Development Assessment

Subject: DA2021/0200 – 1100 Barrenjoey Road PALM BEACH - Additional submission and additional information received

Figure 1 – Extract from Addendum Arborist Report explaining changes to plans, figure from Rain Tree Consulting dated 13 July 2021.

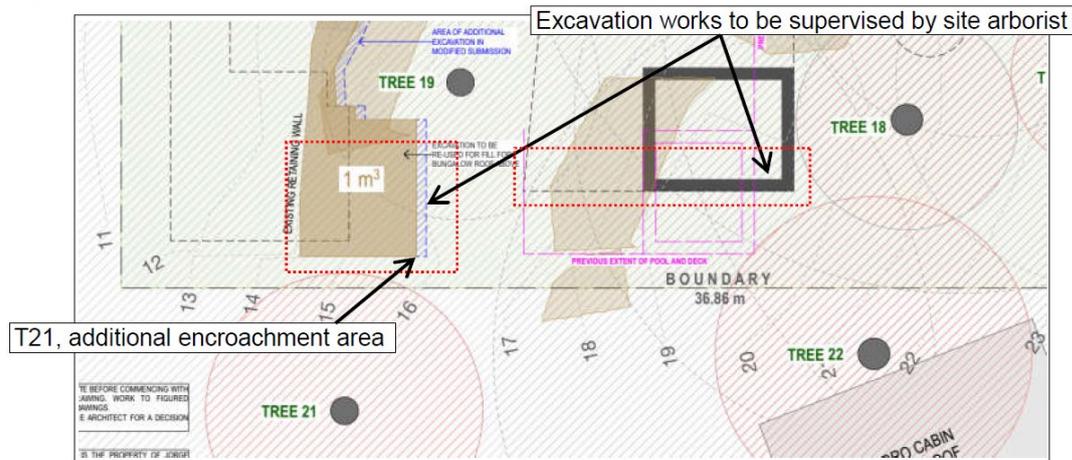
In concluding comments within the Davies Geotechnical Report it states '*We conclude that there are potential adverse effects for No.1100 in regard to the stability of the land at the boundary, and impacts on the two spotted gums T21 and T22 noted in the arborist report, from the proposed excavations on No.1110*'. Furthermore, the Davies Geotechnical report raised issue that the Crozier Report dated 15 December 2020 and the Arborist Report dated 14 January 2021 referenced a previous revision of architectural plans and this should be addressed in the documentation submitted with the DA.

Following receipt of this, Council wrote to the applicant requesting the applicant's geotechnical engineer and arborist provide addendum reports that referenced the latest issue of architectural plans and provide a response to the concerns raised in the submission. It is noted that the latest issue of plans have maintained the same setback for the secondary dwelling and increased the setback for the pool adjacent to the southern boundary (shared with 1110 Barrenjoey Road). A slight increase in the excavated footprint of the secondary dwelling resulted from the amended plans, the changes shown in the below figure and are minor in nature.

The applicant’s Addendum Arboricultural Report reviews and comments on the latest issue of plans and note that the recommendations within the original Arborist Report can continue to apply. It is noted the amended plans provide an increased setback to the pool from the southern boundary and an increased setback from T22. The setback to the southern boundary for the secondary dwelling remains unchanged, with a slight increase in excavation footprint to the east. Council’s Landscape officer has reviewed the addendum report and is satisfied the amended plans will not have an unacceptable impact on T21 and no additional conditions need to be recommended above what is already in the Council assessment report. Condition 1 within the assessment report is recommended to be updated to refer to the addendum arborist report.
